Access Compliance Report

Public Rights-of-Way

(Curb Ramps)

Intersection ID: 19937	Main Street: S_TRYON_ST	Cross Street: THORNFIELD_RD	Location: NE
ADA ID: A6160B96AEFE	Ramp Type: PerpDiag	Initial Pass/Fail: Pass	Overall Compliance: No
Severity Score: 5.25			
Codes/Mitigation Info/Possible Solution		Field Measurements/Component Compliance

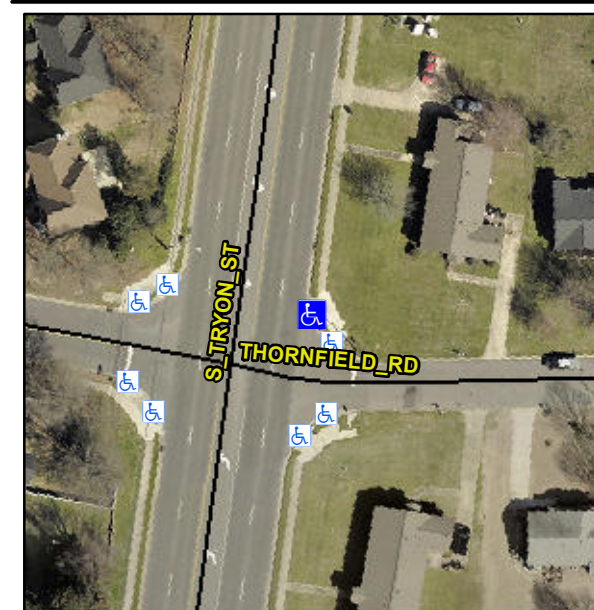
Not Found, R304.5.3, R304.5.4

Compliance	Description	Data	Compliance	Description	Data
N/A	Ramp Length (in)	90.0	Yes	Ramp Slope (%)	5.5
Yes	Ramp Width (in)	48.0	No	Ramp XSlope (%)	3.2
N/A	Flare Type LT	Sloped	N/A	Flare Type RT	N/A
N/A	Flare Slope LT (%)	12.2	N/A	Flare Slope RT (%)	1.5
N/A	Flare Traversable LT?	No	N/A	Flare Traversable RT?	No
Yes	Landing Length (in)	48.0	Yes	DWS Provided?	Yes
Yes	Landing Width (in)	48.0	Yes	DWS Contrast?	Yes
Yes	Landing Slope (%)	1.8	Yes	DWS Length (in)	24.0
Yes	Landing X Slope (%)	1.4	Yes	DWS Full Width?	Yes
N/A	Landing Curb? (Y/N)	No	Yes	DWS Offset (in)	2.0
N/A	Shared Landing?	No			
Yes	Gutter Ponding?	No	No	Gutter Slope (%)	5.5
Yes	Gutter Lip Ht (in)	0.0	No	Gutter X Slope (%)	5.1
N/A	Painted X Walk1?	No	N/A	Painted X Walk2?	No
	X Walk 1 Direction	To W		X Walk 2 Direction	To S
N/A	X Walk 1 Width (in)	N/A	N/A	X Walk 2 Width (in)	N/A
	X Walk 1 Slope (%)	6.8		X Walk 2 Slope (%)	3.1
	X Walk 1 X Slope (%)	2.0		X Walk 2 X Slope (%)	5.9

N/A	Ramp inside XWalk1?	N/A	N/A	Ramp inside XWalk2?	N/A
	Road Slope (%)	4.3	N/A	Clear Space?	Yes
	Road X Slope (%)	1.3	N/A	Clear Space to XWalk (in)	N/A
Yes	Any Obstructions?	No	Yes	Storm Grate/Utility Hazard?	No
	Obstruction Type			Storm Grate/Utility Type	
		N/A			N/A
			Yes	Surface Condition? (G/P)	Good

Remove & Replace Curb Ramp With Two New Directional Ramps or Equivalent. Remove & Replace Gutter.
